CONSTRUCTION DIRECTIVE (CD)

PROJECT: Oak Street ES LAWA Sound Mitigation Project
CD Number: 02

TO: Newman Midland Corporation – Adam Nasry
TITLE: Phase 1- Demo Five (5) Hard Lid Ceilings –
Bldg. B

REQUEST FOR INFORMATION (RFI)

RFI TITLE: Ceiling at Electrical room at bldg. B

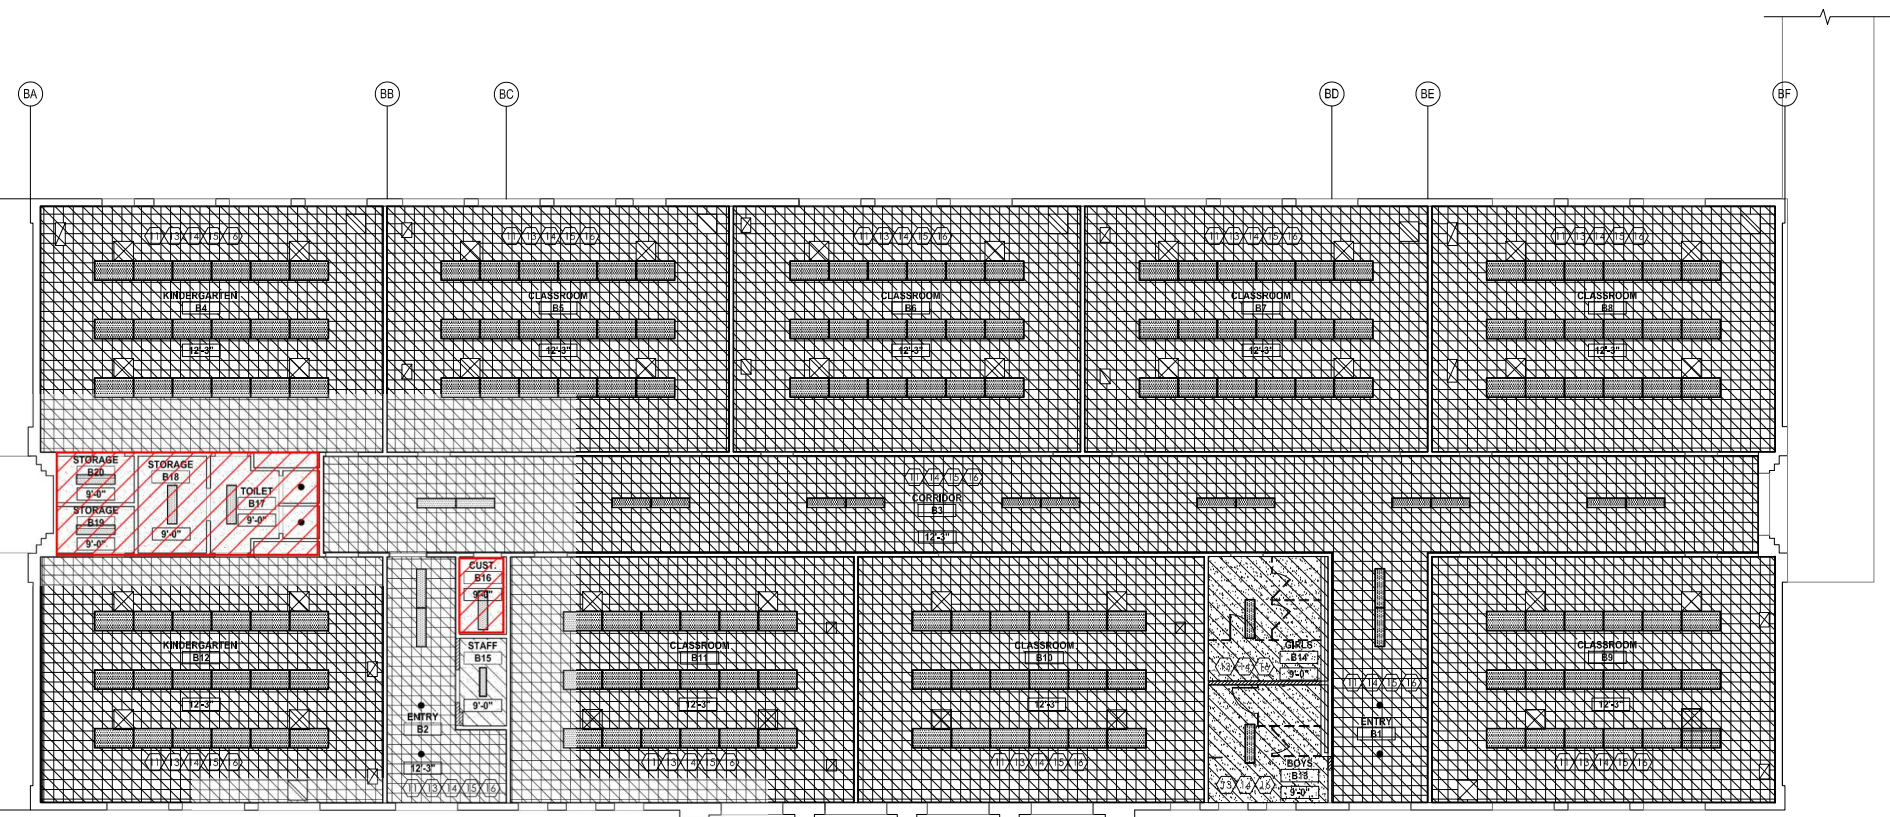
Per RFI#16 answer and Noel's subsequent email, we were requested to provide a proposal to Abate and Replace (E) asbestos ceilings in rooms B16 through 20. We propose to leave ceiling in the electrical room (B16) as is, due to extensive electrical work and panels in that room.

No exception. District to confirm request.

According to our on site inspector, and the abatement contractor's supervisor, the electrical room shares a common ceiling space with the hallway and room B11. The roofing debris cannot be left in order to achieve clearance for the work area. The ceiling and roofing debris must be abated.
